Tice River Homes Legacy

model
36-04

project #
17052

A5

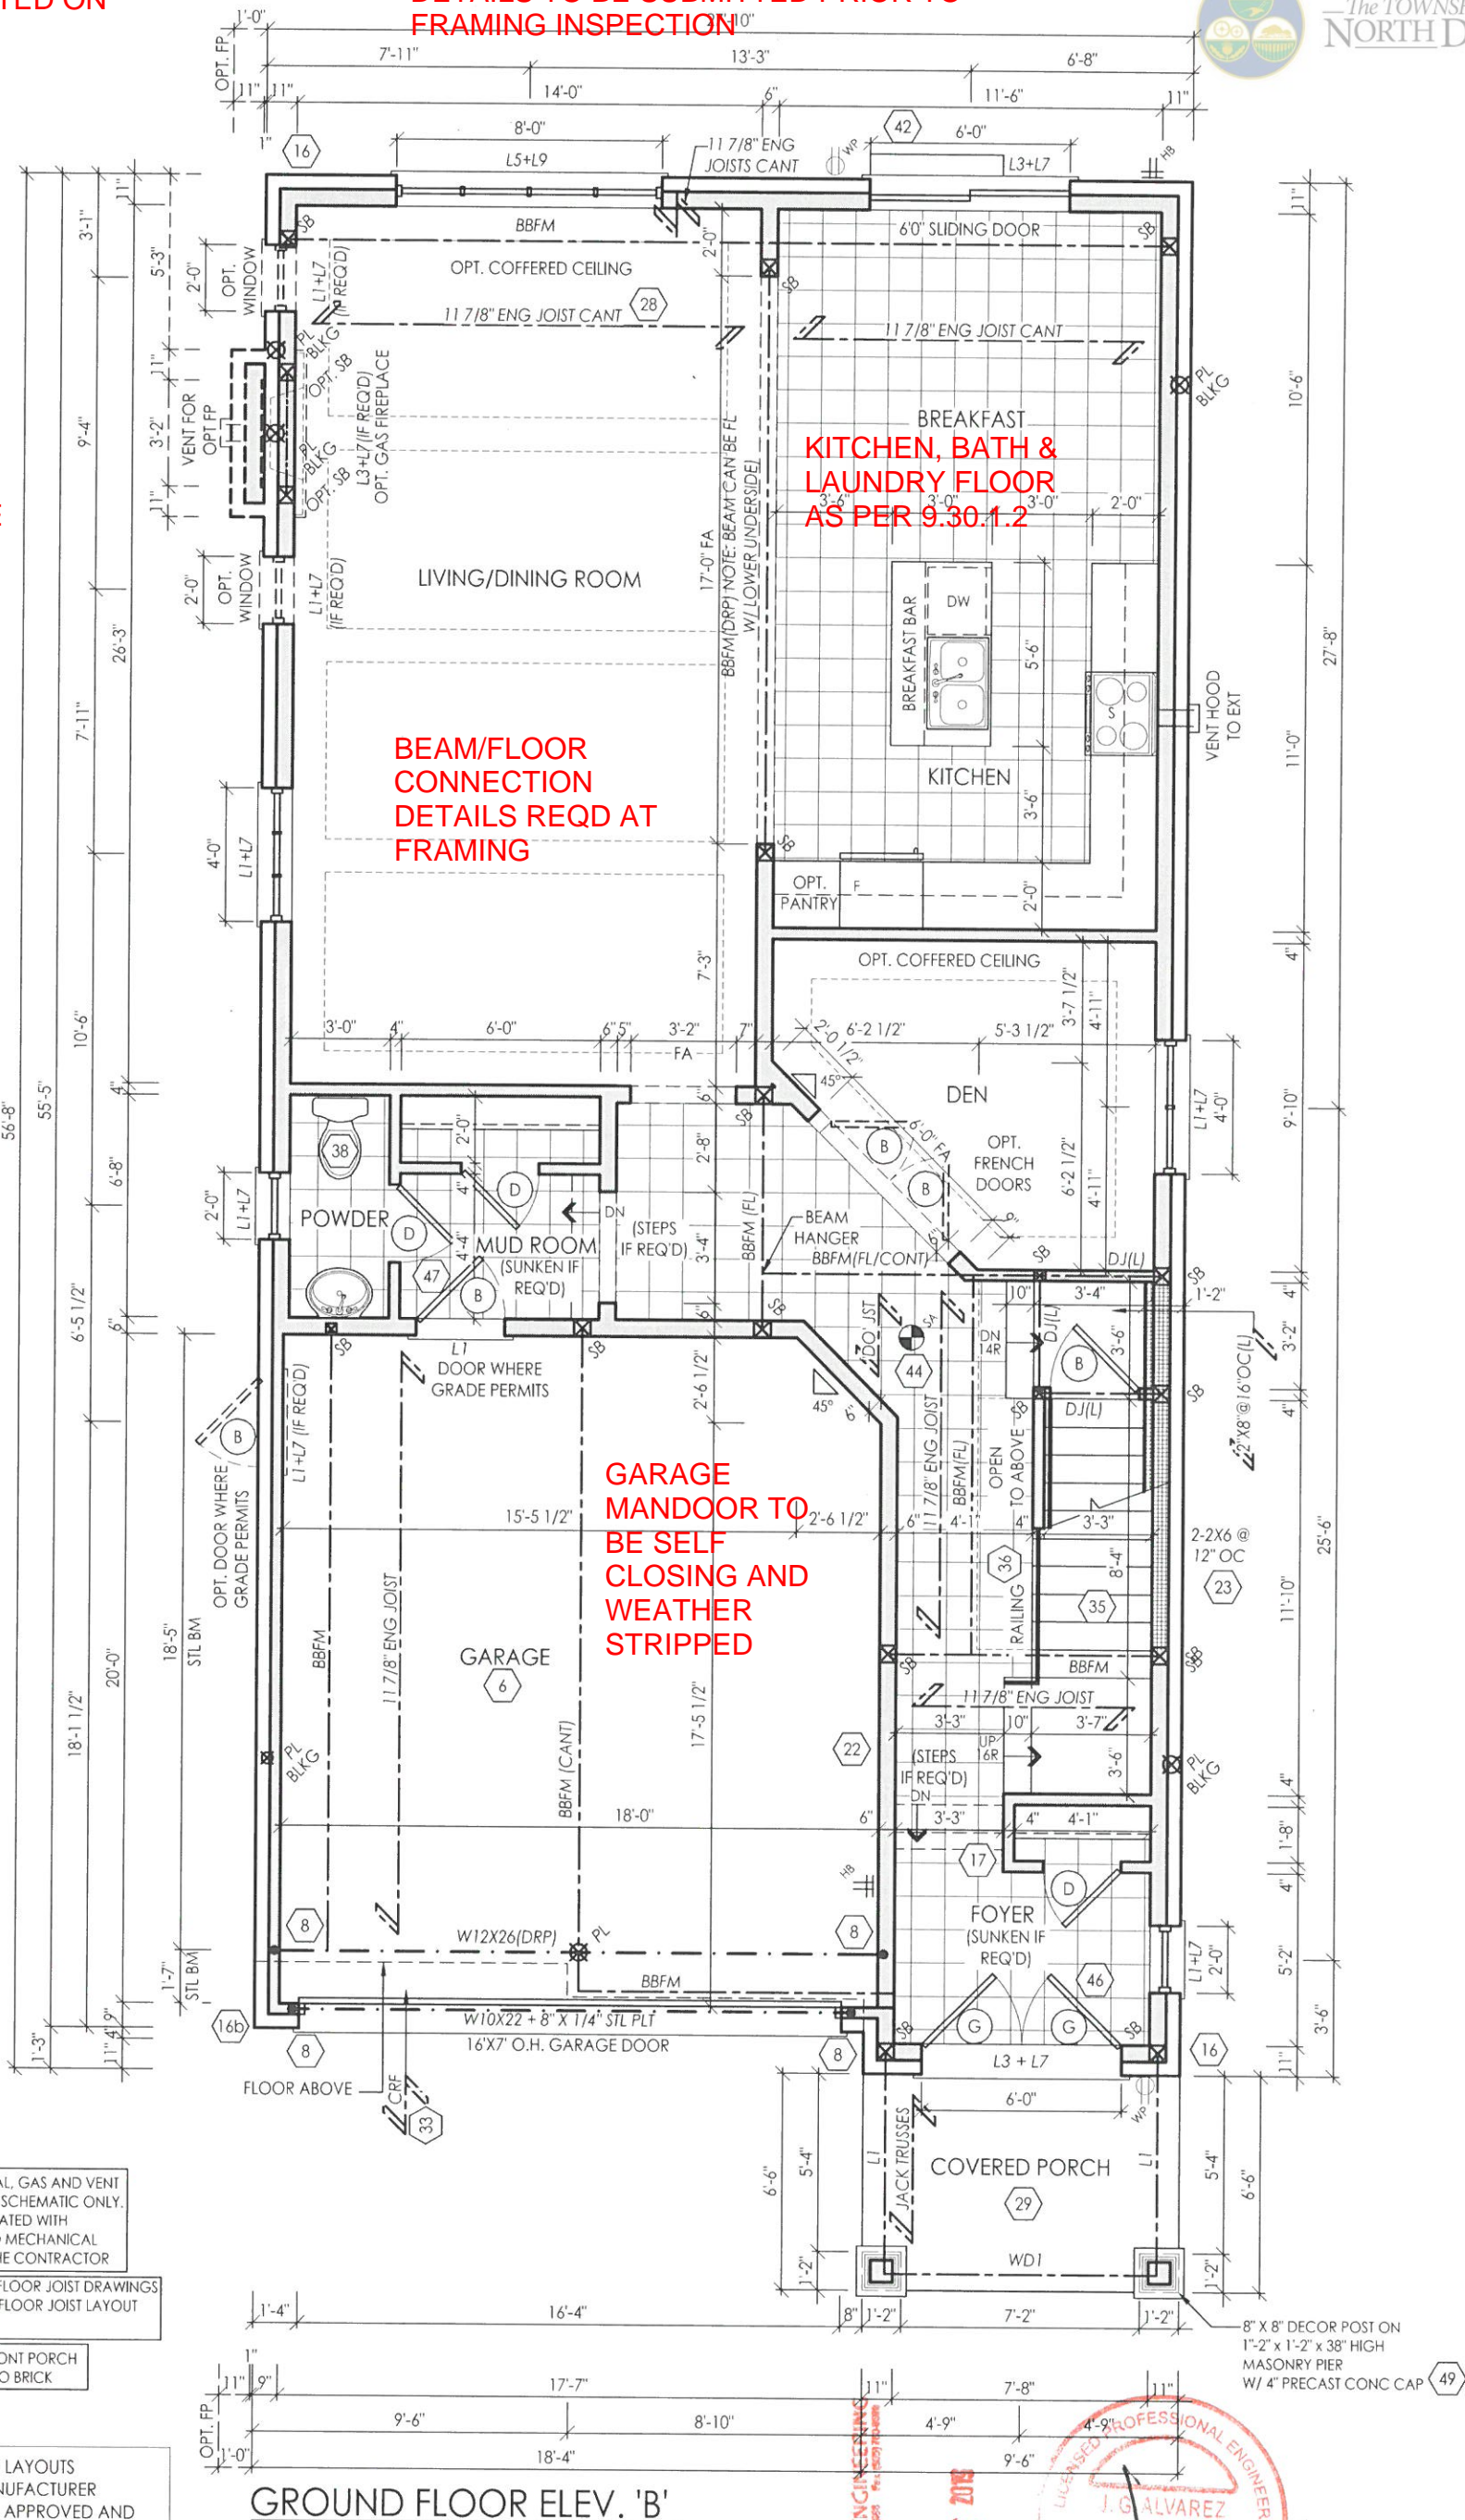
BEAM AND LINTEL
SIZES TO BE NOTED ON
FUTURE PLANS

LINTEL PACKAGE AND ENGINEERED BEAM
DETAILS TO BE SUBMITTED PRIOR TO
FRAMING INSPECTION

MAX
PROJECTION
INTO REQD SIDE
YARD 0.3M

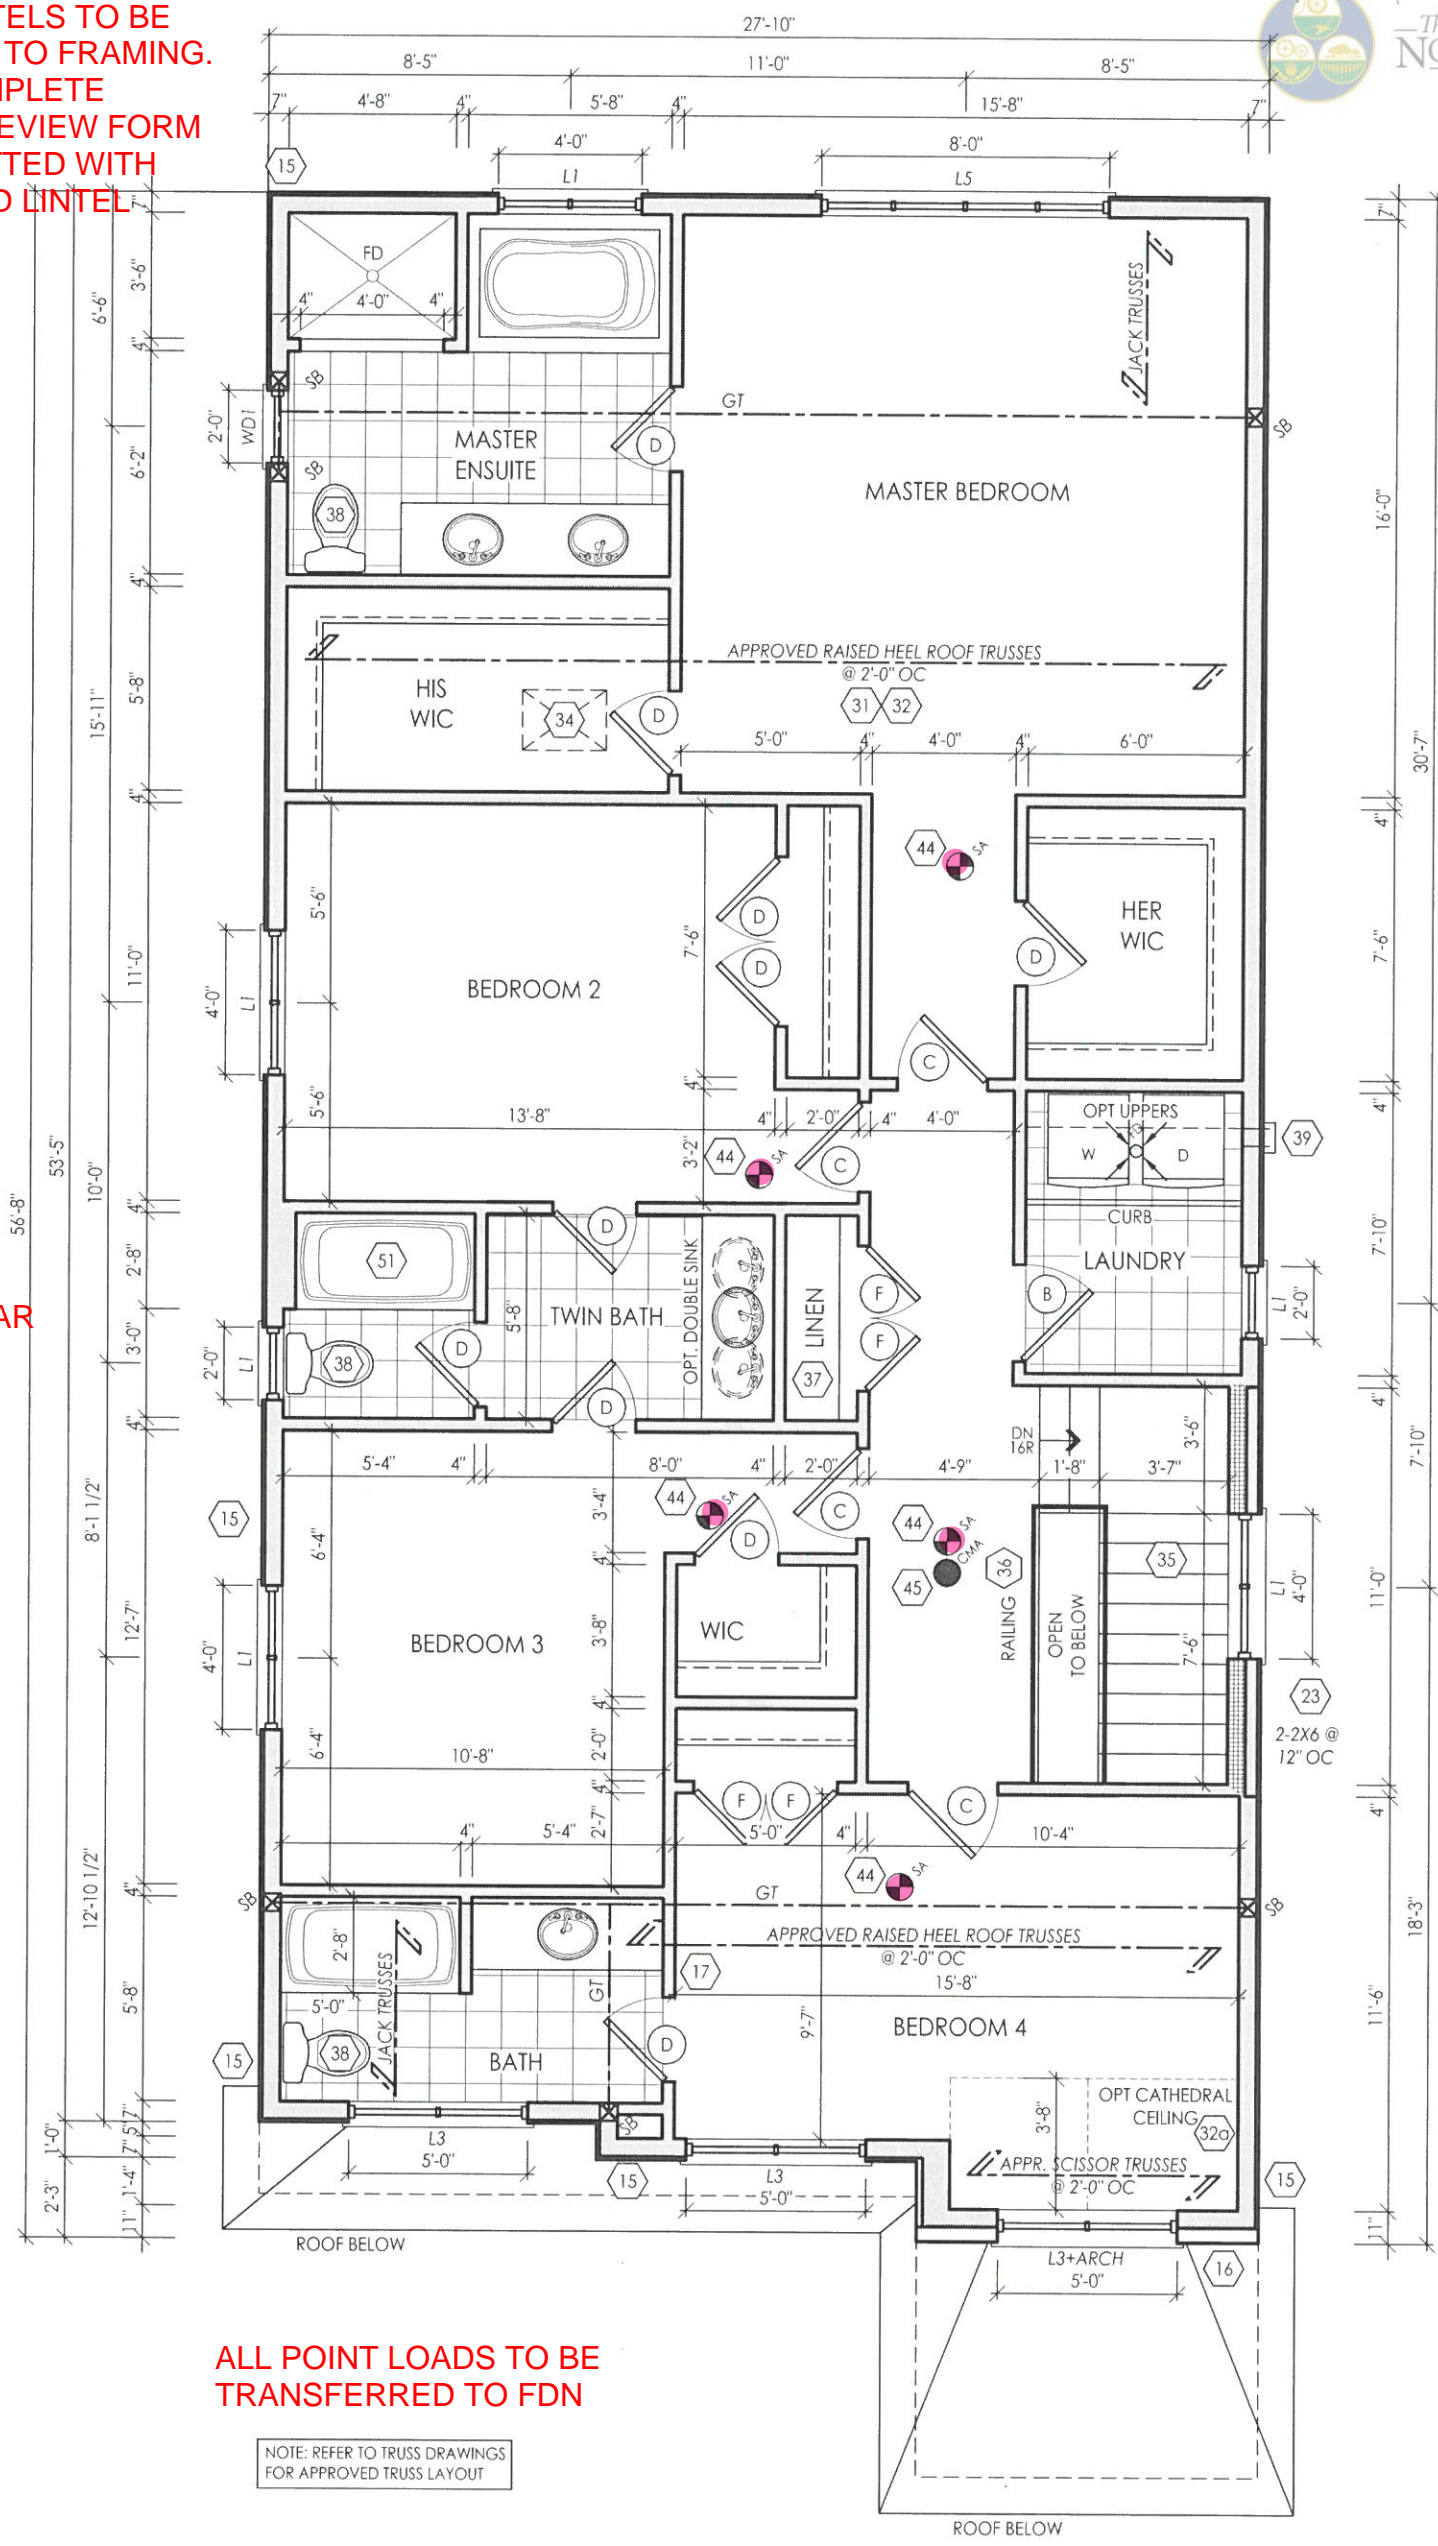
ENGINEERED FLOOR LAYOUT, TRUSSES AND LINTELS TO BE SUBMITTED PRIOR TO FRAMING. DESIGNER TO COMPLETE RESPONSIBILITY REVIEW FORM AND TO BE SUBMITTED WITH TRUSS, FLOOR AND LINTEL DOCUMENTS.

MAIN BATH TO HAVE GRAB BAR BLOCKING

WINDOW ON LANDING MUST BE HIGHER THAN 3' ABOVE OR ENGINEERING ON WINDOW OR GUARD REQD

ALL POINT LOADS TO BE TRANSFERRED TO FDN

RIGHT SIDE ELEVATION 'B'

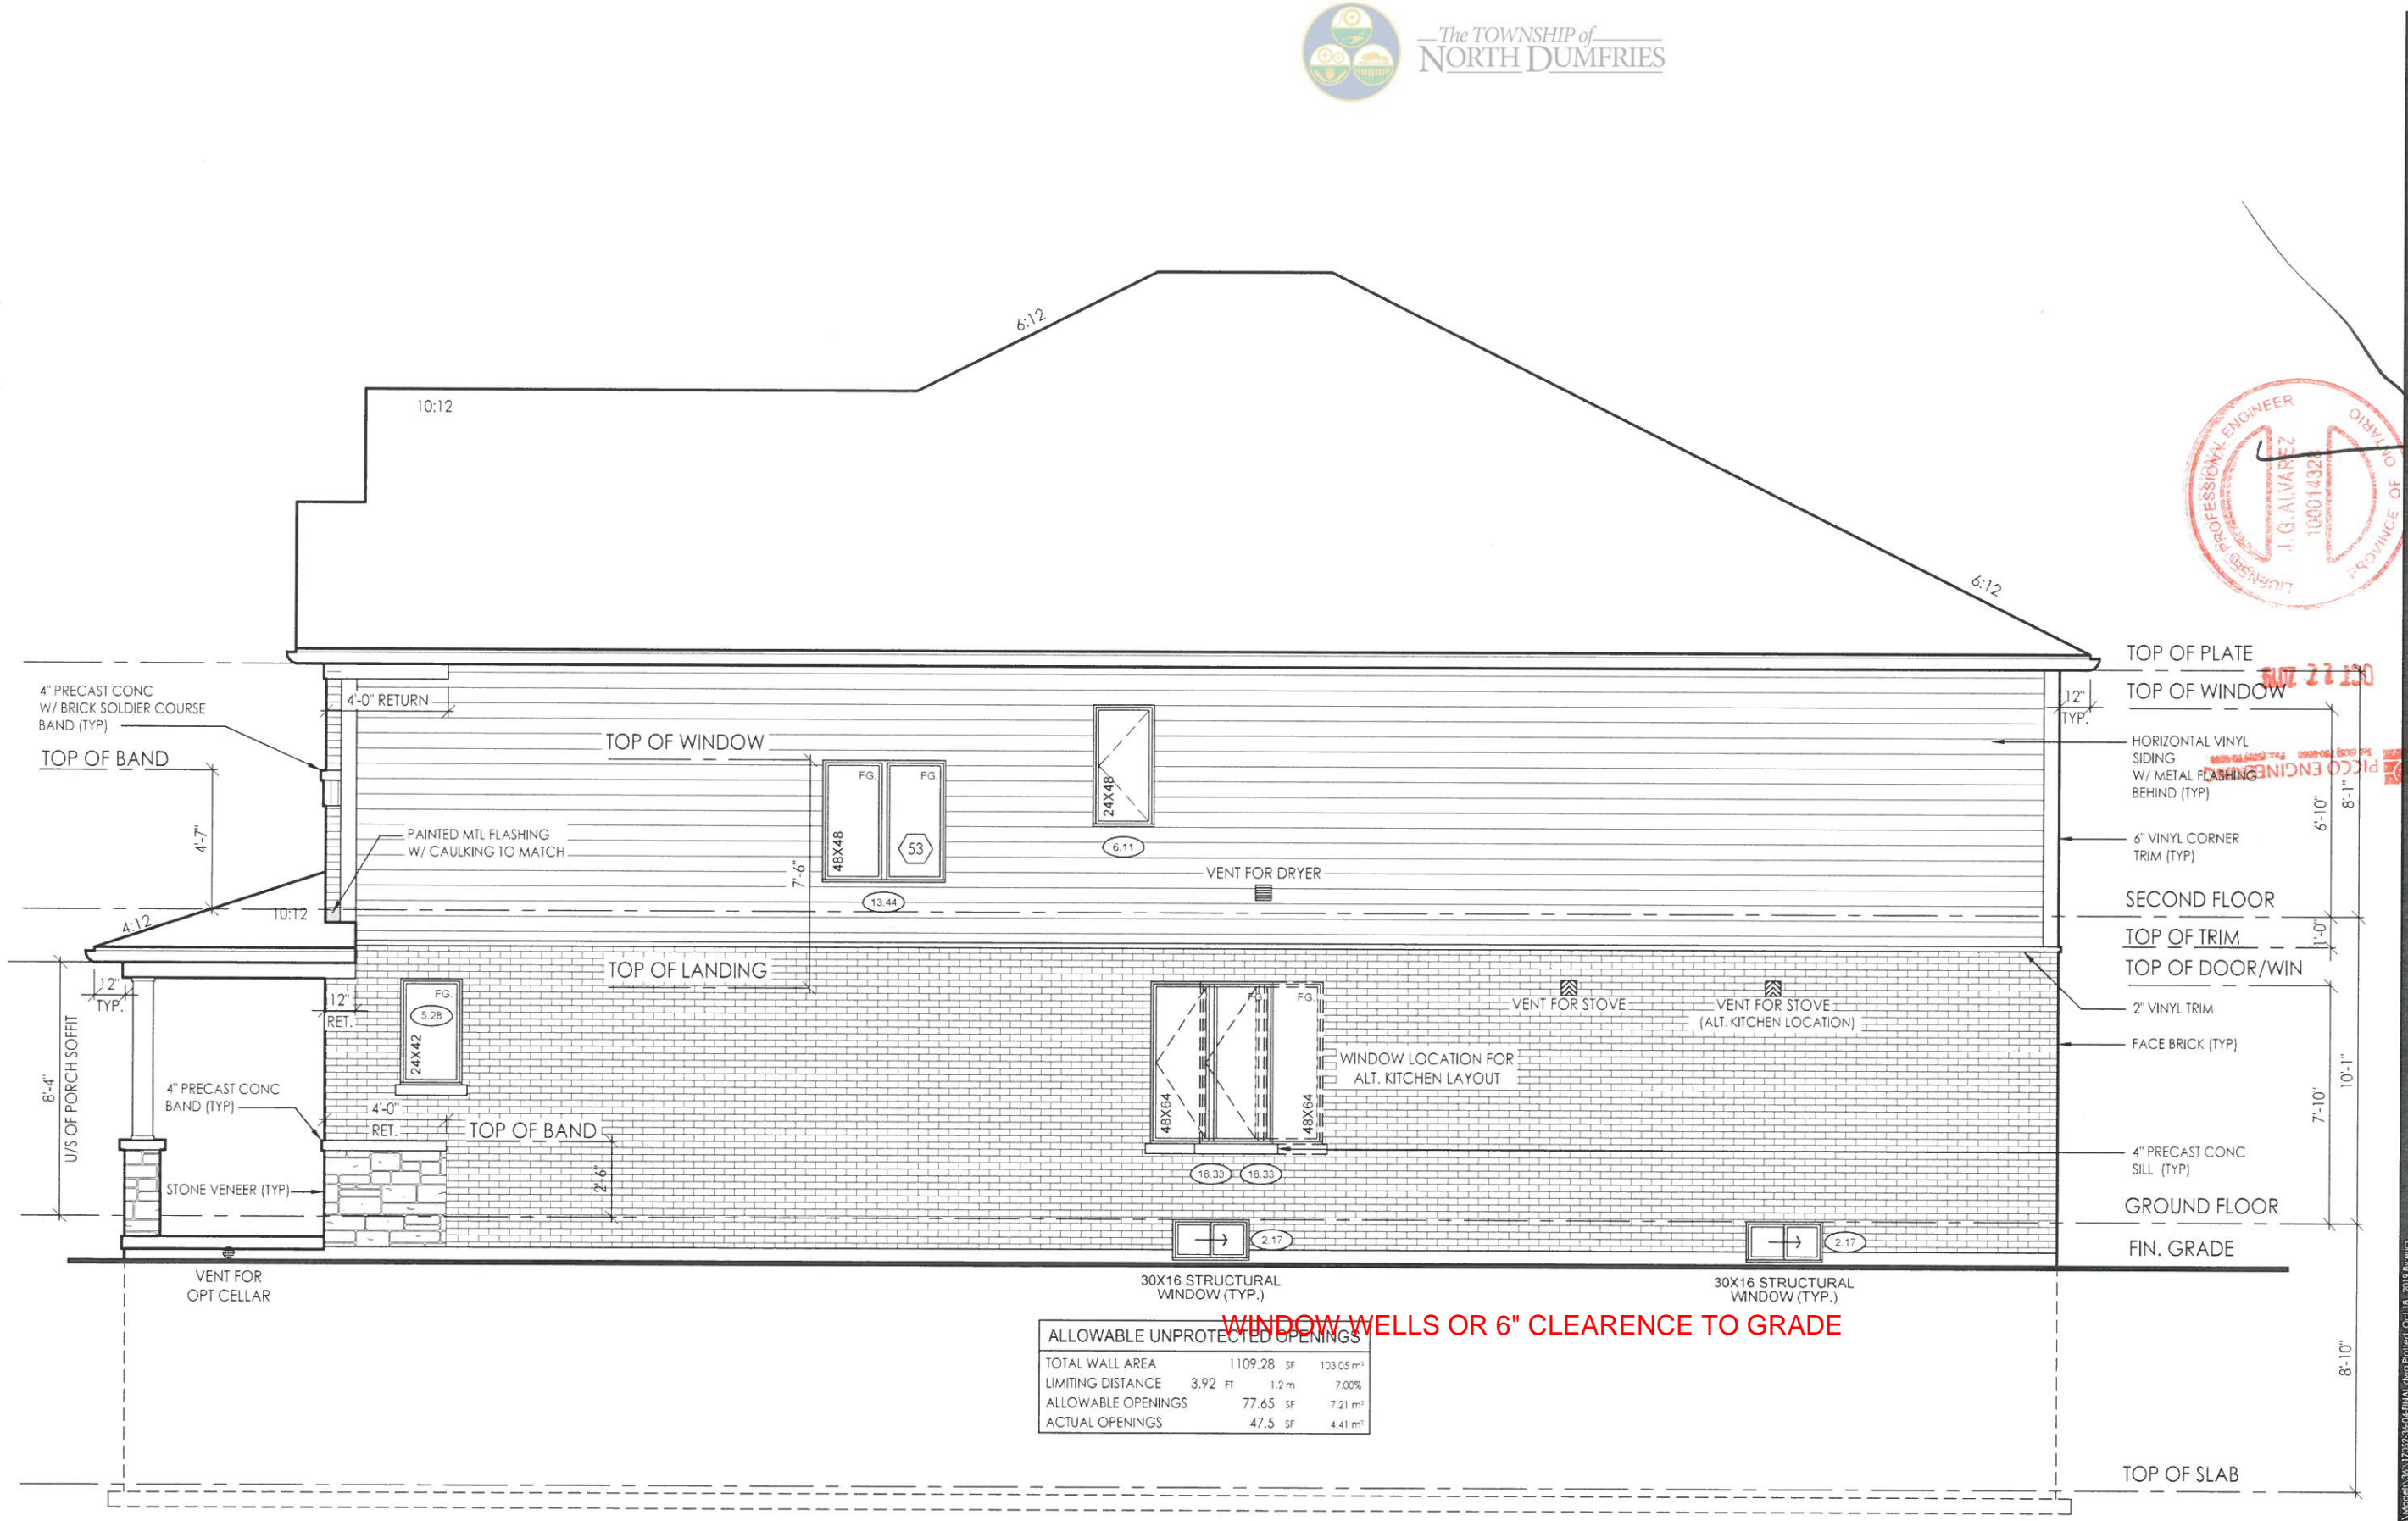
WINDOW WELLS OR 6" CLEARANCE TO GRADE
